PLANNING TECHNICAL REVIEW COMMITTEE –AGENDA

1. 10:30 AM – 11:00 AM: Amendment for Downtown Dover Storage, LLC, Assessor's Map 4, Lot 5, zoned CBD-G, located at 14 Broadway. (Proposal is to construct a 14,770 s.f. 4-story residential building with 38 units with revised covered parking and relocating internal staircase.) (WAIV-2024-0004) *[This item was previously heard by the Planning Technical Review Committee on March 28, 2024]*

PLAN SNAPSHOT REPORT WAIV-2024-0004 FOR CITY OF DOVER, N.H.

Re: Response to TRC Comments Letter
Proposed Residential Development at 14 Broadway

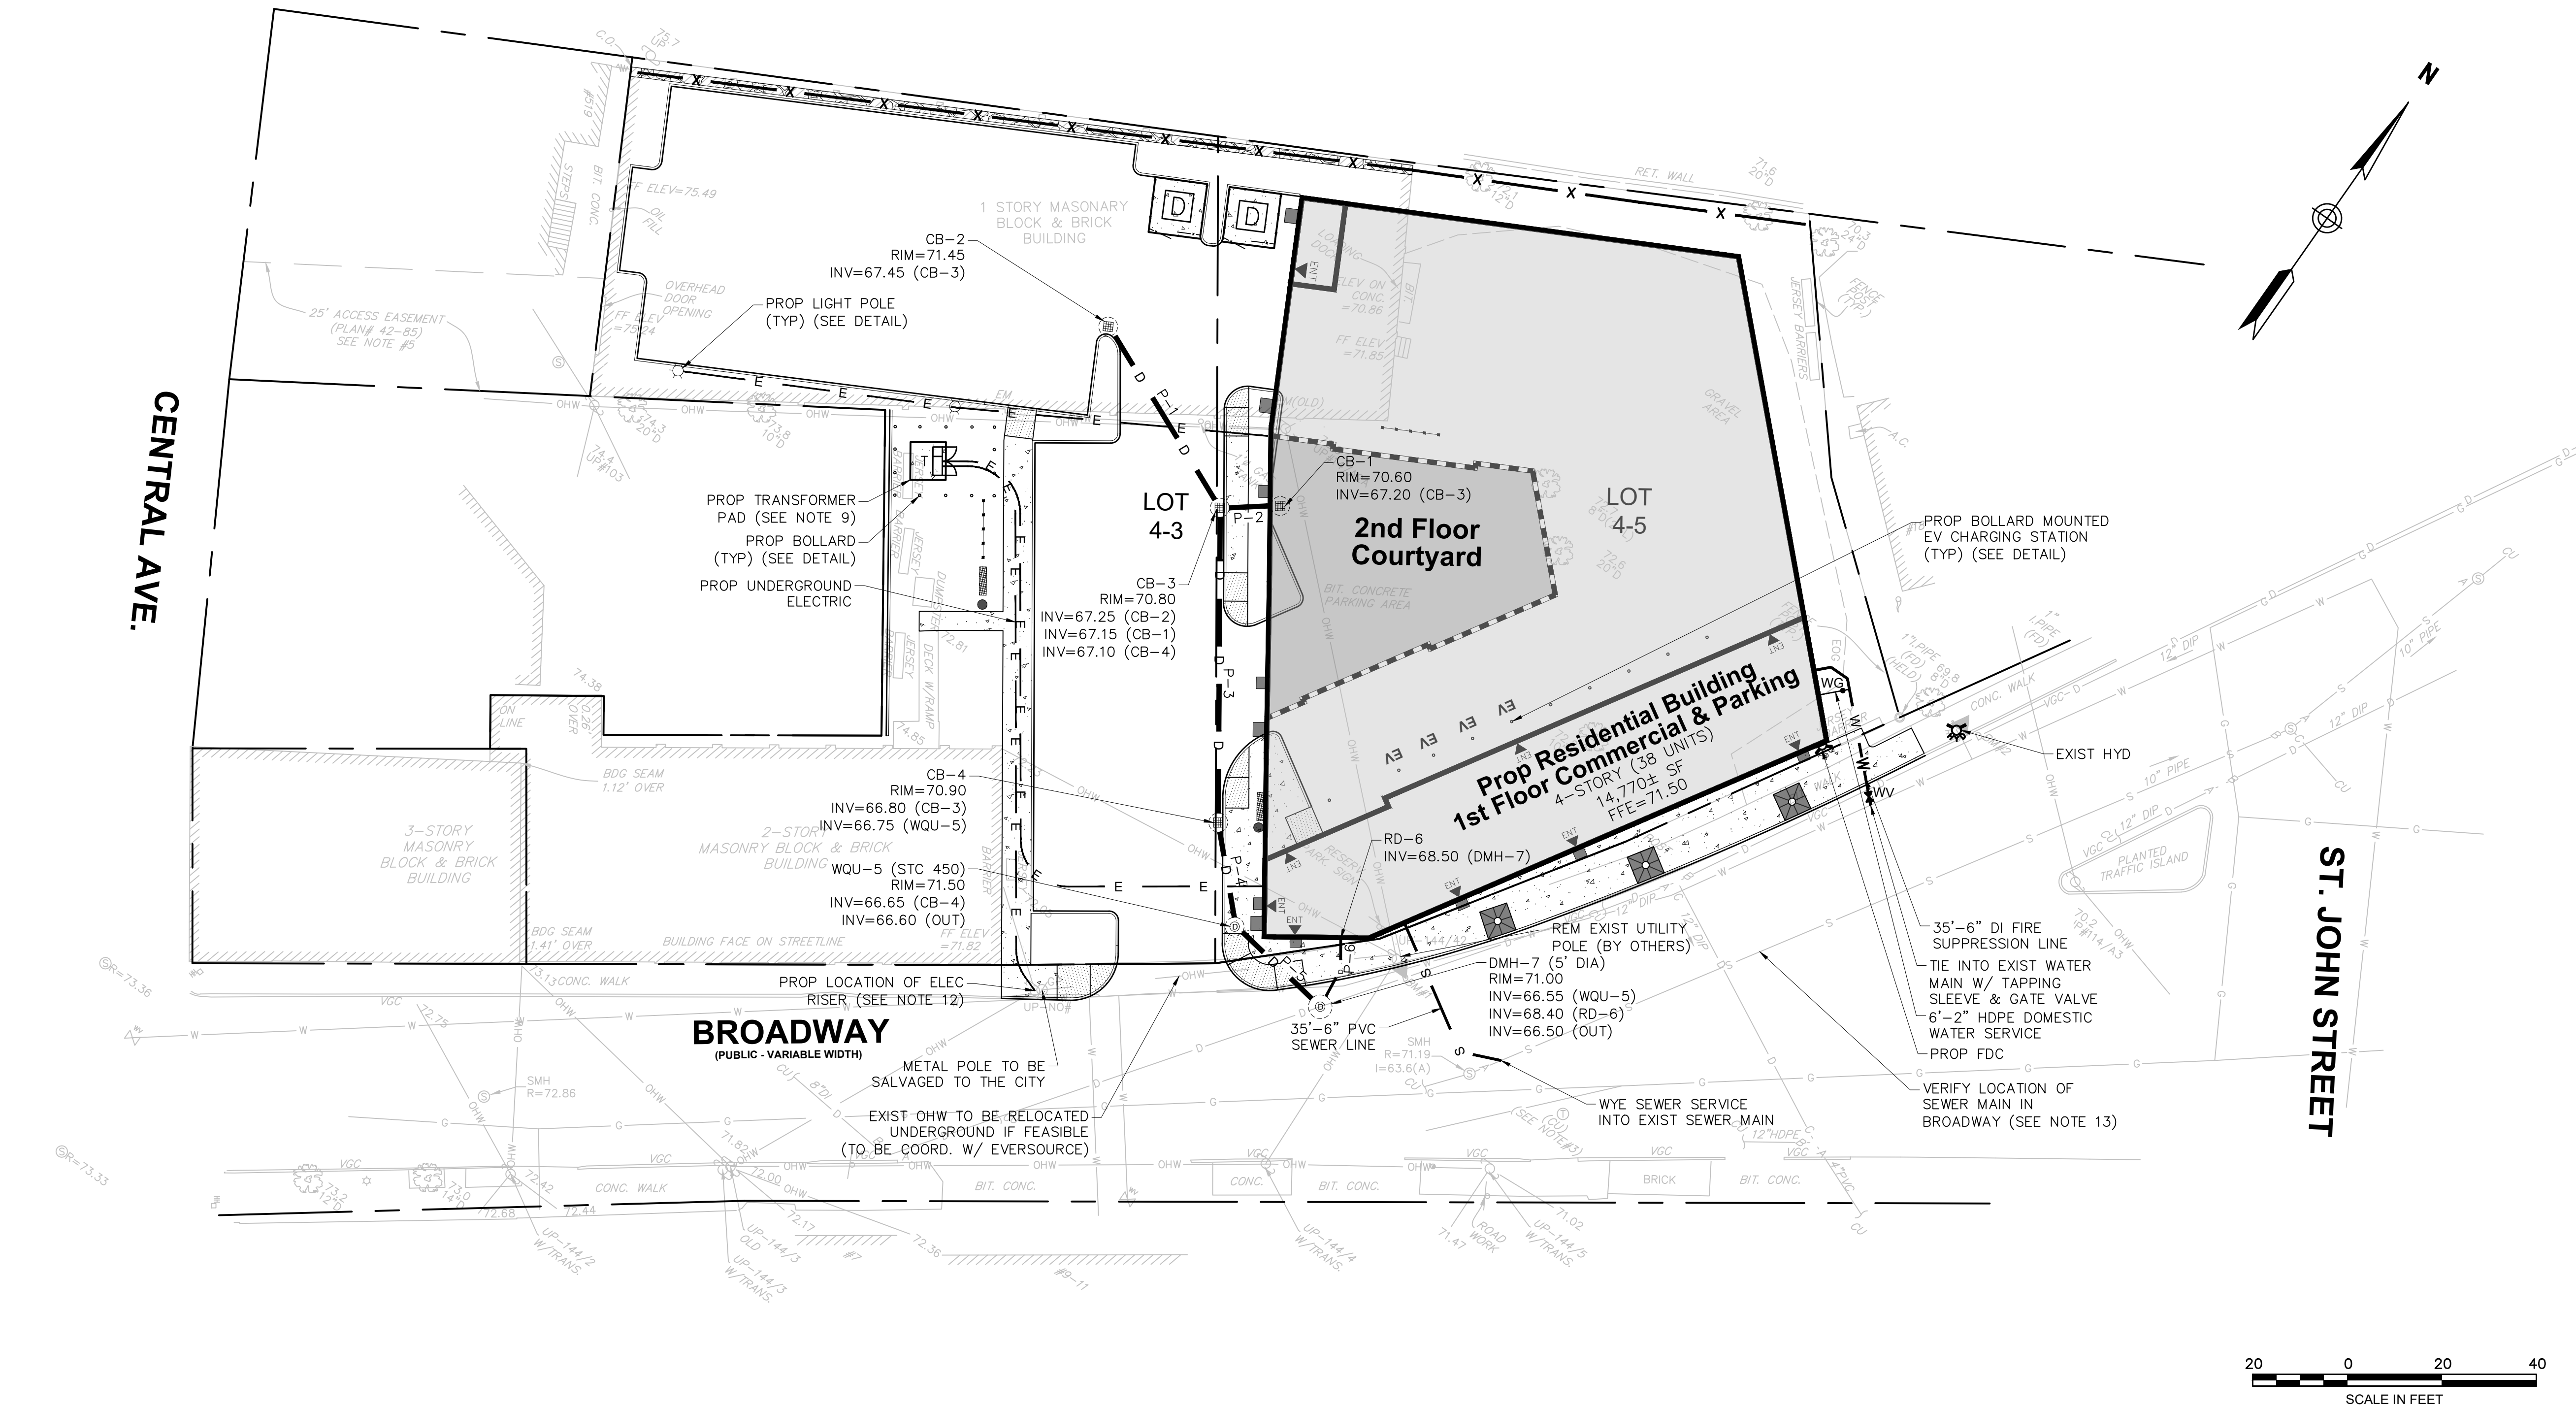
- Sheet C-7

- Show slope of proposed pipes on plan.
- Show existing water services cut and capped at water main in Central and Broadway.

- The sewer main in Broadway does not match the City's GIS database. The sewer runs towards St. John Street.
- Show the 6-inch sewer service wye into the sewer main not into the SMH.
- The sewer main that is being connected to may be an 8-inch PVC not a 10-inch as indicated on the plans.
- Show the existing sewer service cut and capped in Central Ave.
- There is an existing metal pole at the location of the proposed electric riser pole. Please note that that metal pole shall be salvaged to the City.

- **Show existing water services cut and capped at water main in Central and Broadway.**
A note has been added to the Utility Plan (Sheet C-7) that the locations of utility services to the existing building from Central and Broadway shall be verified prior to construction and cut and capped at the main.

- **The sewer main in Broadway does not match the City's GIS database. The sewer runs towards St. John Street.**
A note has been added to the Utility Plan (Sheet C-7) to verify the location of the sewer main within Broadway prior to construction.

- **Show the 6-inch sewer service wye into the sewer main not into the SMH.**
The 6-inch sewer service has been revised to wye into the sewer main rather than into the SMH in Broadway as shown on the Utility Plan (Sheet C-7).

- **The sewer main that is being connected to may be an 8-inch PVC not a 10-inch as indicated on the plans.**
A note has been added to the Utility Plan (Sheet C-7) to verify the size of the sewer main within Broadway.

- **Show the existing sewer service cut and capped in Central Ave.**
A note has been added to the Utility Plan (Sheet C-7) that the locations of utility services to the existing building from Central and Broadway shall be verified prior to construction and cut and capped at the main.

The existing metal pole at the location of the proposed electric riser pole has been called out to be salvaged to the City as shown on the Utility Plan (Sheet C-7).

DRAWING NUMBER:
PB-08

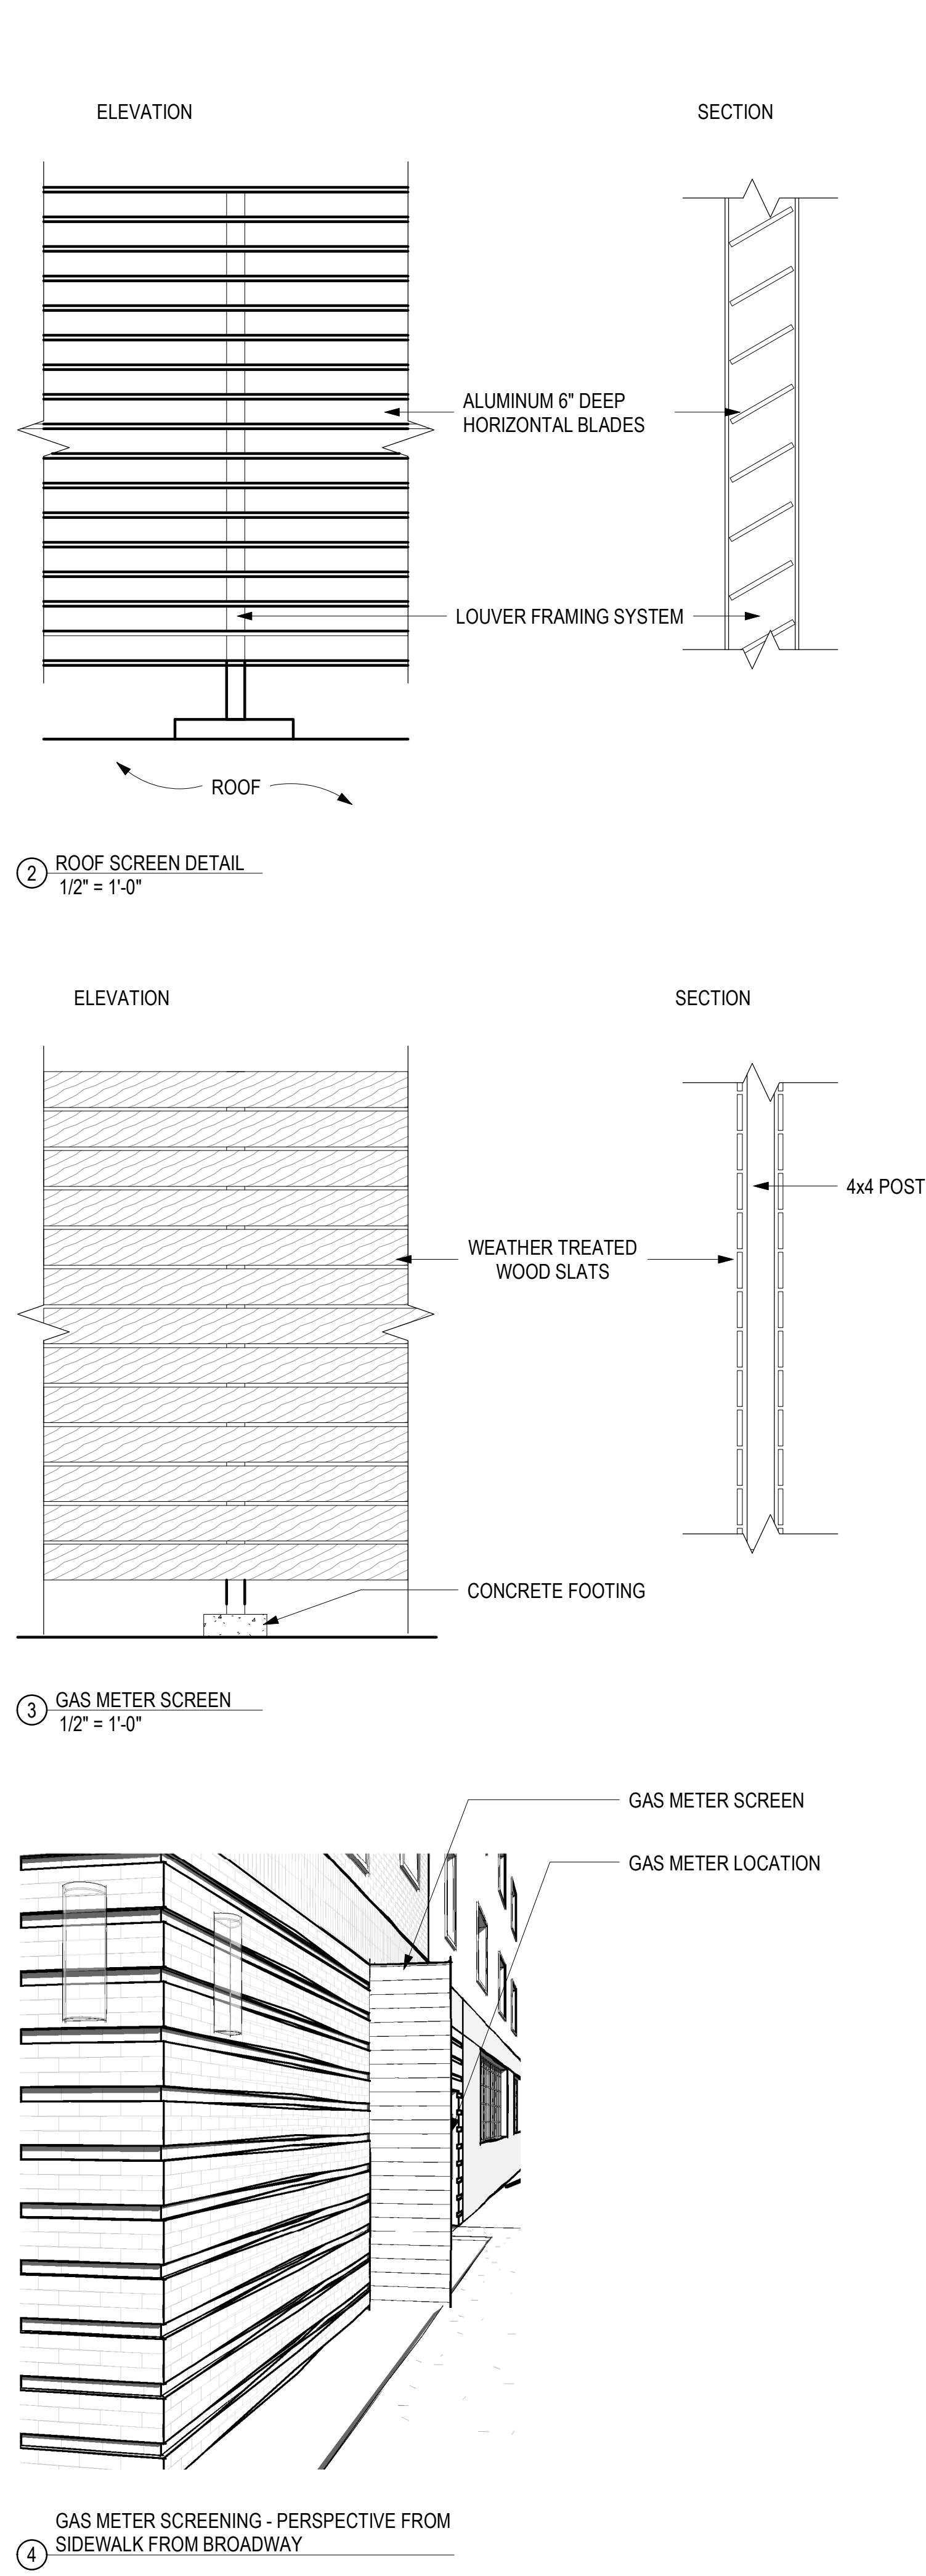
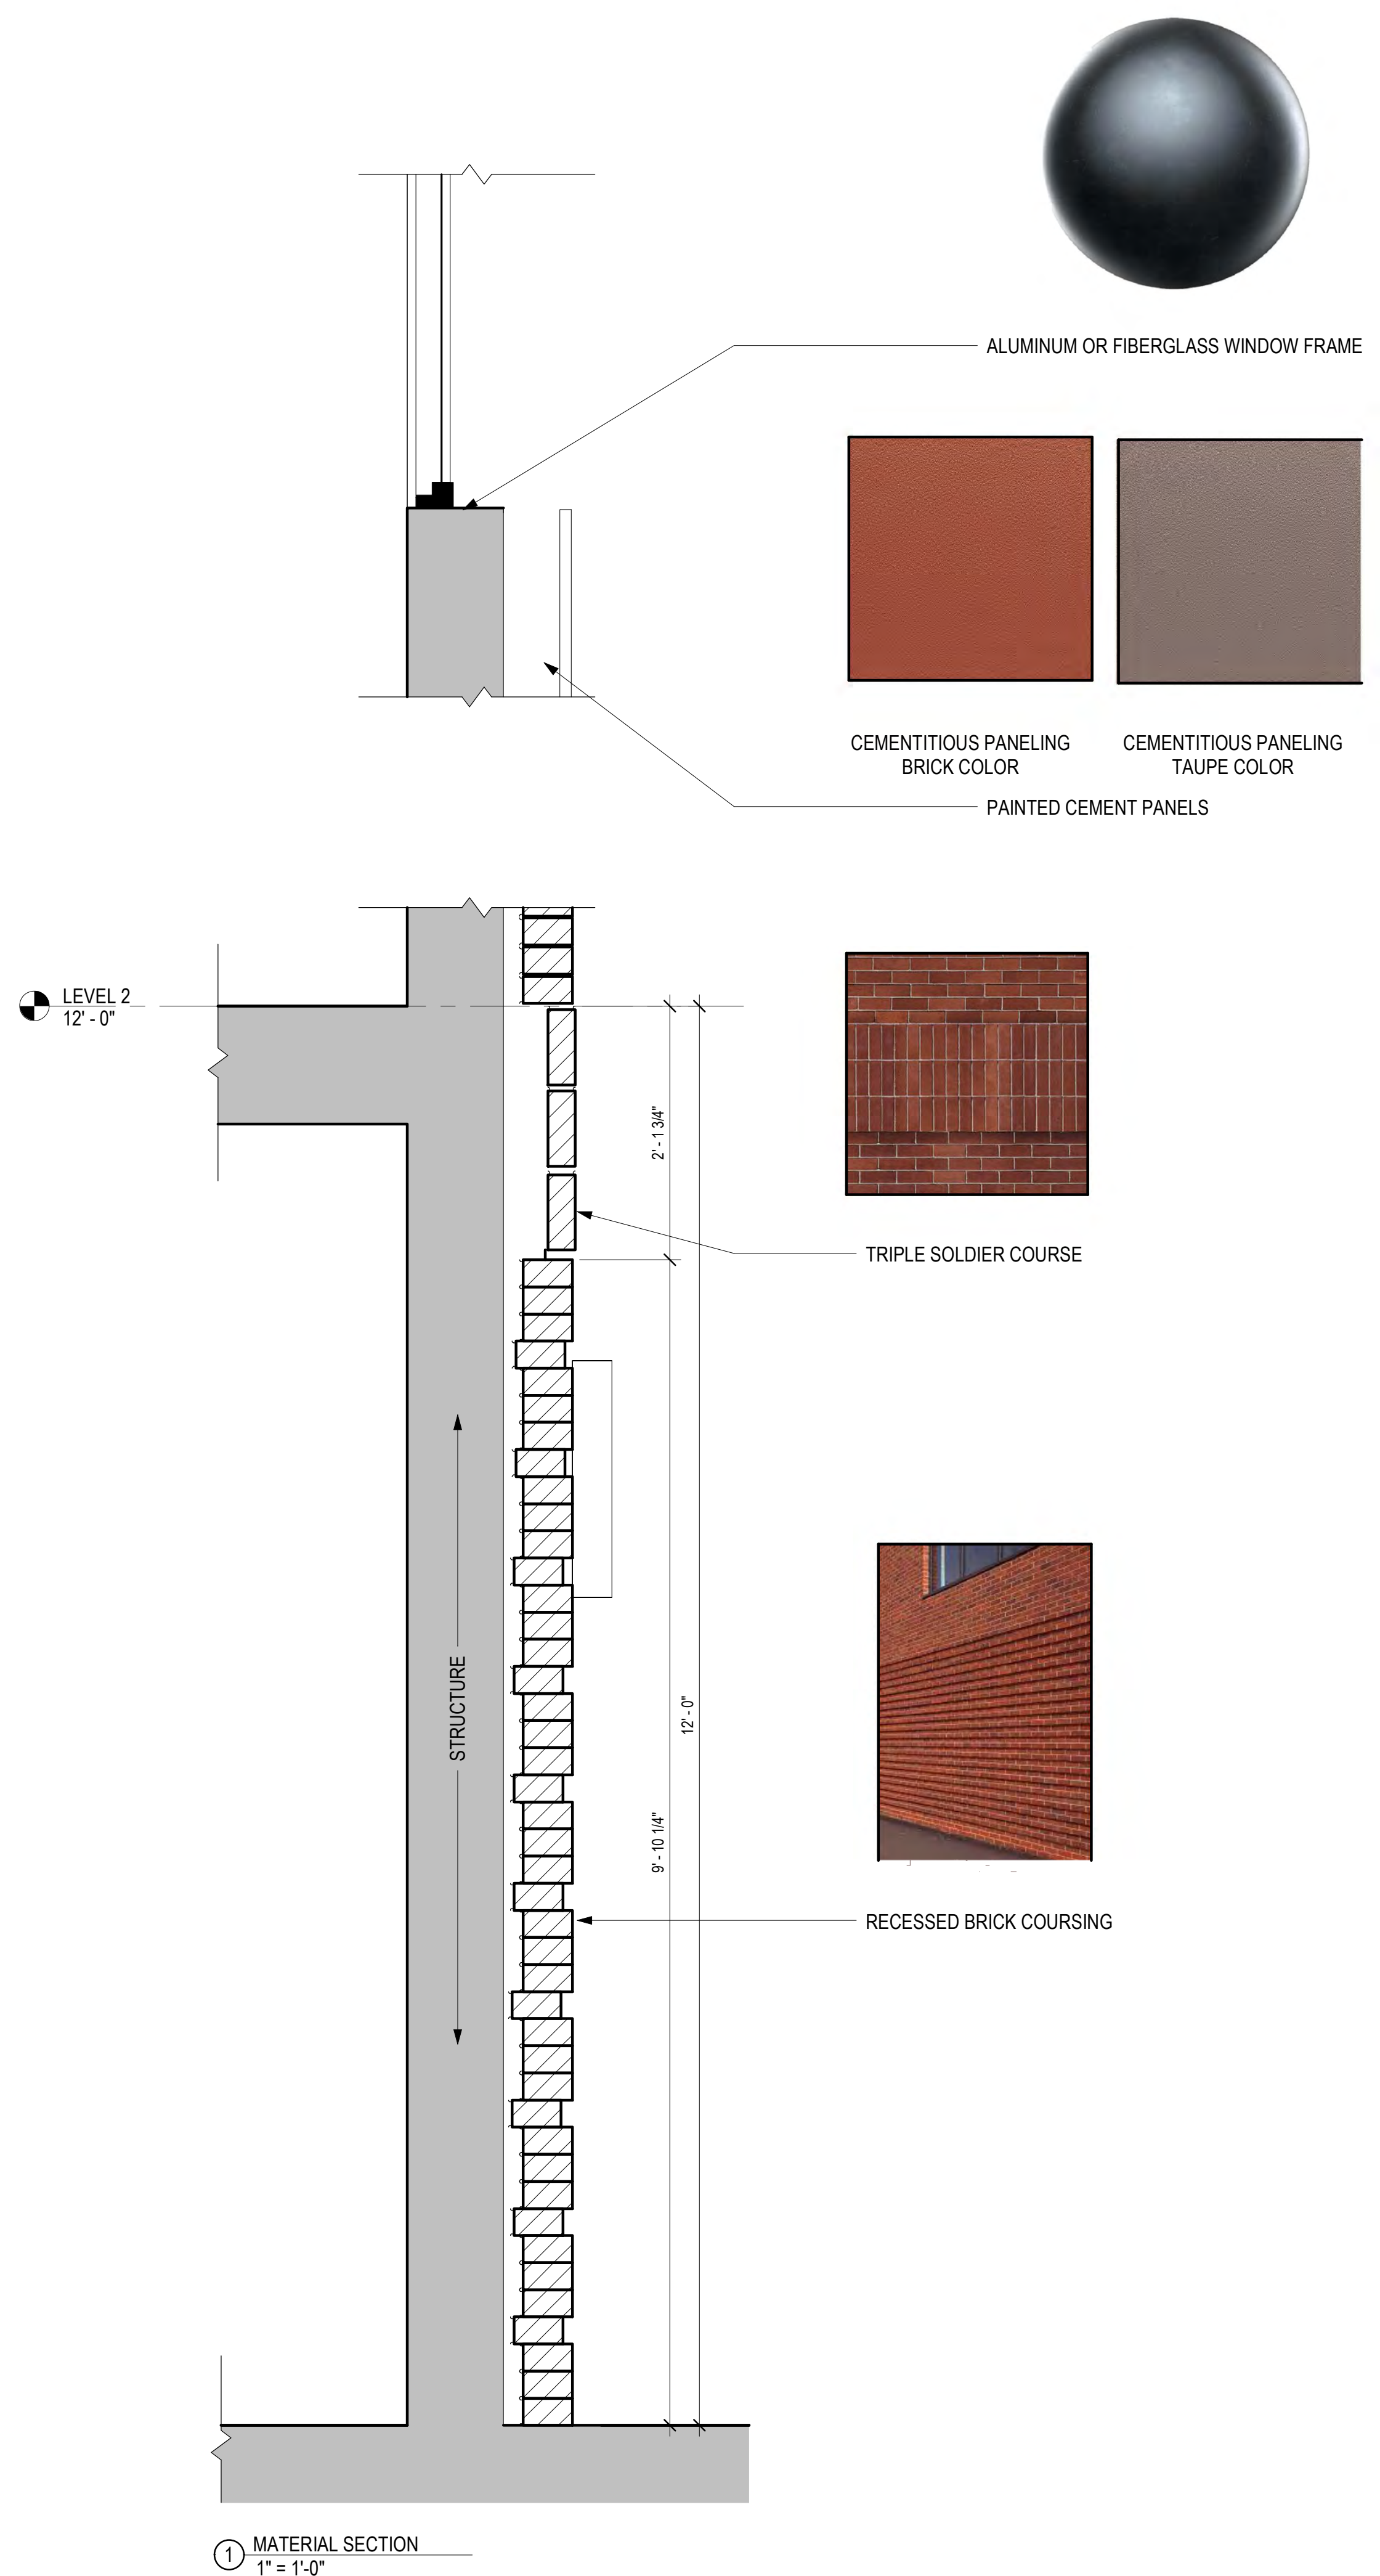
5. **Sheet PB-08, View from Broadway Looking North: is red façade color intended to match adjacent property? Consider toning down the bright red.**

The red façade color has been toned down so it's more in keeping with traditional Dover brick. Please see revised architectural plans.
